From: Trevor Woodgate [redacted]
Sent: 30 August 2019 14:34
To: Amber Willard <Amber.Willard@arun.gov.uk>
Cc: Planning <Planning@arun.gov.uk>; Cllr. Hugh Coster [redacted] Cllr. Tony Dixon [redacted] Cllr. Martin Lury [redacted]
Subject: Further Objection to AW/134/19/HH RevA - Two storey extension at 33 Balliol Close, West Meads, Bognor Regis

Planning Application Ref: **AW/134/19/HH** (Rev A, submitted 20/8/2019) – Single Storey side and rear extension with rooms in roof, together with porch removal and replacement windows – 33 Balliol Close, West Meads, Bognor Regis.

Sunpath diagram listed as 1 January 3pm

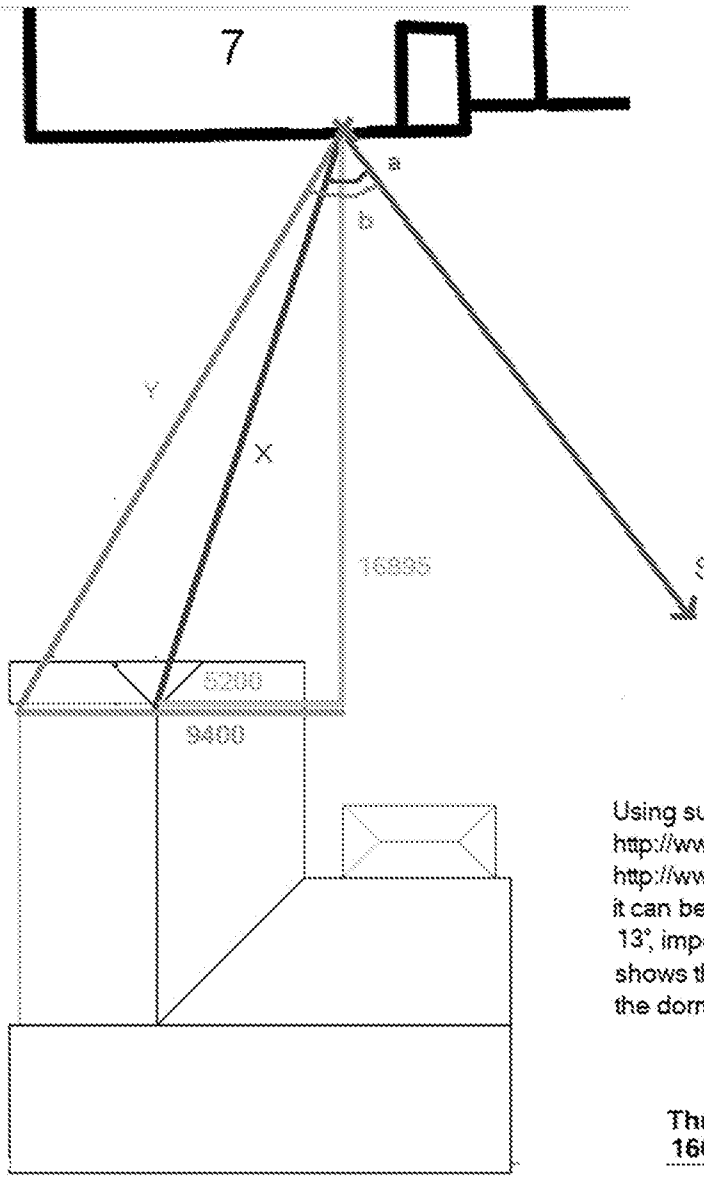
This set of unsubstantiated "Sunpath" diagrams are incorrect and misleading and give a false impression that the shadowing cast by this this proposed extension will not really interact with our dwelling. Firstly by choosing times of day favourable to their purpose, and secondly by having incorrect angles of elevation and bearing for those times of day chosen. Correct shadowing calculations using proven solar data, that I have been given permission to use are provided on the next page.

For 3pm on 1 January the angle of elevation of the sun is 7°
The height of the dormer is 5.5m
As such we are looking at a shadow triangle that looks like this...

So tan(7°) = 5.5/X therefore X = 5.5/tan(7°) = **44.8m**

Given that the drawings provided in the Sunpath diagram are suggesting a shadow of about 23m in length, this drawing is suggesting the sun is at an angle of evelation almost twice that it is in reality (an angle of elevation the sun barely reaches at it's meridian this time of year). The bearing of the shadow is off too. All the diagrams suffer from these issues

As such these diagrams cannot be used as reliable evidence of the shadowing the proposed development will cast on our dwelling

X = SQRT(16895*16895)+(5200*5200)) = 17677

Y = SQRT((16895*16895)+(9400*9400)) = 19334

Extension is roughly 5.5m high, so an elevation of approximately 4.5m from our windows.

tan(e1) = 4500/ 17677
e1 = 14.28°

tan(e2)=4500/ 19334
e2 = 13.1°

using measurements from the front of my house so as to place myself at the red cross, and a compass I was able to determine angle a is at a bearing of 233°
and angle b is at a bearing of 280°

Using sunrise and sunset data from
http://www.timeanddate.com/sun/uk/southampton?month=9&year=2019 and
http://www.timeanddate.com/sun/uk/southampton?month=3&year=2019
it can be determined that the dormer prominence at 250° bearing and an angle of elevation of 13°, imposes the most shadowing. Expanding the sun's path for the days in these months shows that from the 28th September to the 15 March, the suns angle of elevation is such that the dormer prominence will cast a shadow **within** our dwelling.

Thus demonstrating we will experience shadowing within our dwelling 166 days in the year as a result of the proposed extension
